UNITED STATES
DEPARTMENT OF THE INTERIOR
BUREAU OF LAND MANAGEMENT
APPLICATION FOR PERMIT TO DRILL OR REENTER

**EOG RESOURCES, INC.
GUTSY BUN 4 FED COM #710H**

PECOS DISTRICT DRILLING CONDITIONS OF APPROVAL

OPERATOR'S NAME:	EOG RESOURCES INCORPORATED
LEASE NO.:	NMNM113939
WELL NAME & NO.:	GUTSY BUN 4 FED COM 710H
SURFACE HOLE FOOTAGE:	418'/N & 935'/E
BOTTOM HOLE FOOTAGE:	230'/S & 1254'/E
LOCATION:	Section 04, T.26 S., R.26 E., NMPM
COUNTY:	Eddy County, New Mexico

Proposed Wellbore
Design A

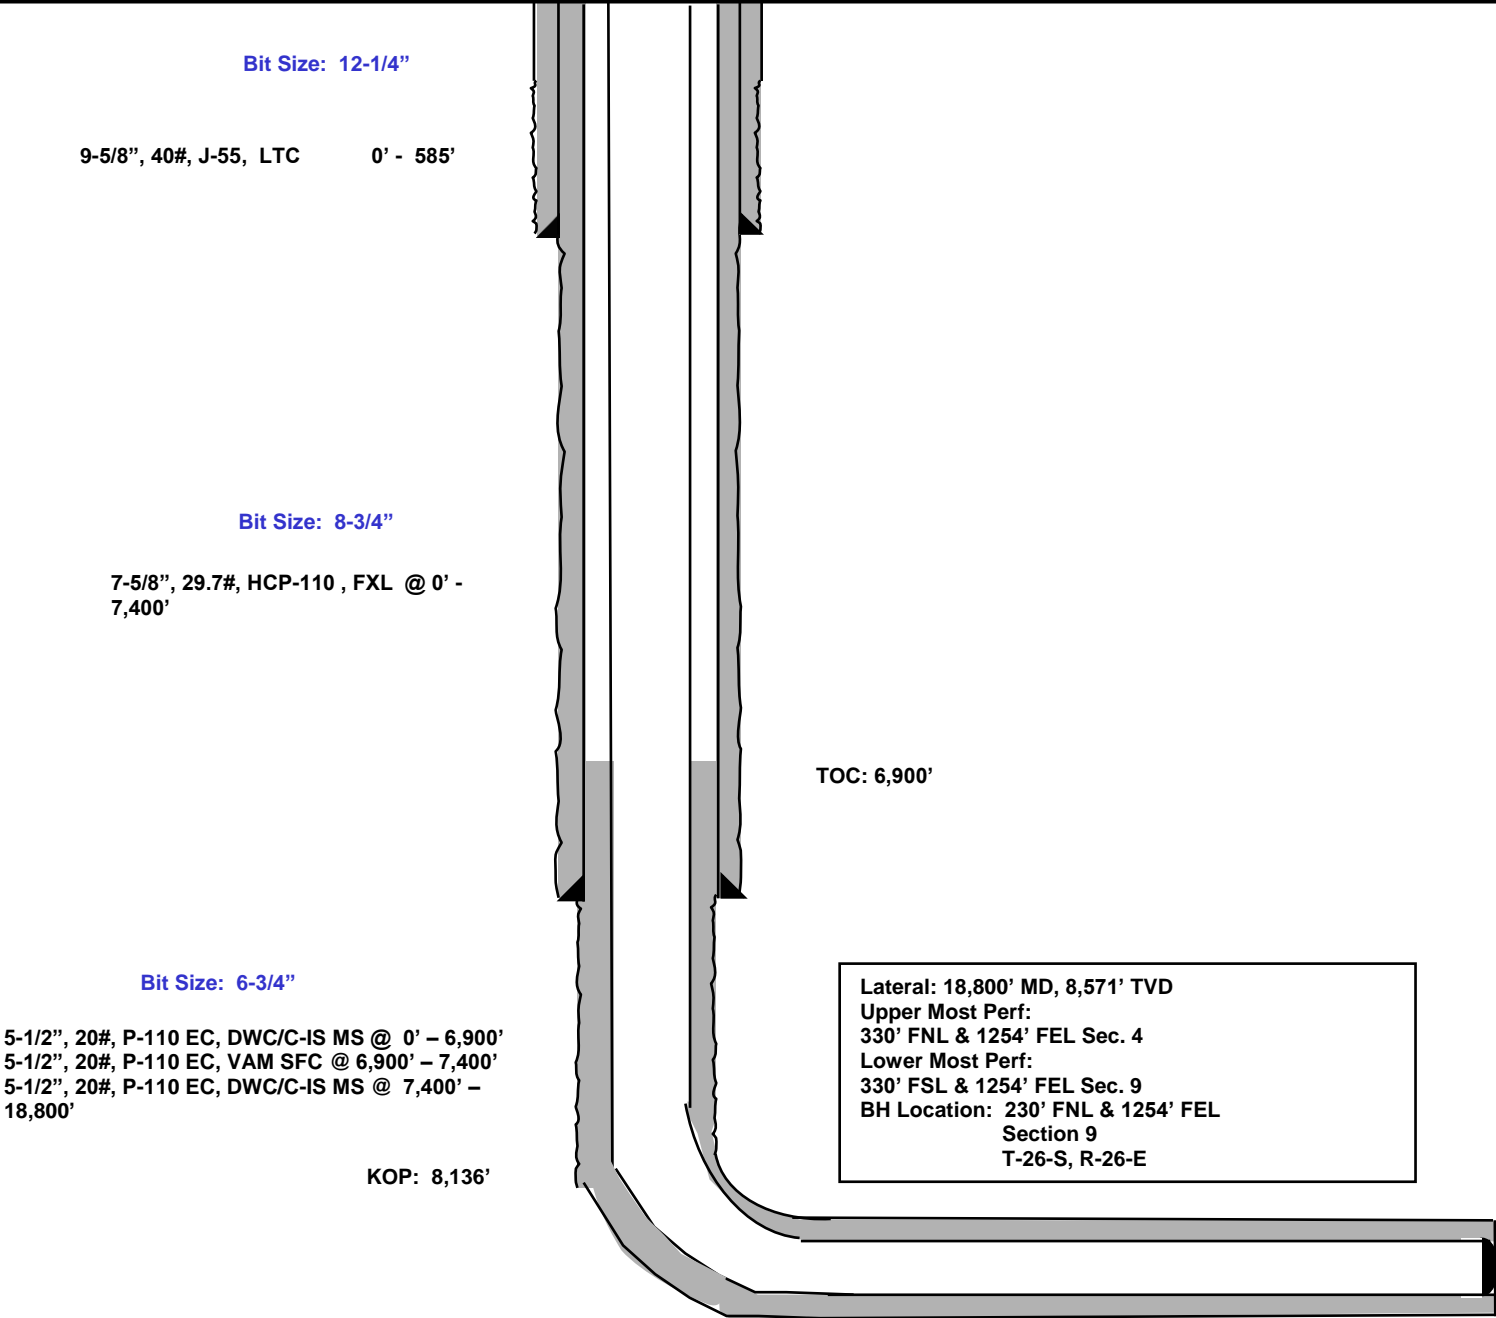
1. The **9-5/8** inch surface casing shall be set at approximately **350 feet** (a minimum of 70 feet (Eddy County) into the Rustler Anhydrite and above the salt) and cemented to the surface.
 - a. If cement does not circulate to the surface, the appropriate BLM office shall be notified and a temperature survey utilizing an electronic type temperature survey with surface log readout will be used or a cement bond log shall be run to verify the top of the cement. Temperature survey will be run a minimum of six hours after pumping cement and ideally between 8-10 hours after completing the cement job.
 - b. Wait on cement (WOC) time for a primary cement job will be a minimum of **8**

- Cement should tie-back at least **200 feet** into previous casing string. Operator shall provide method of verification.
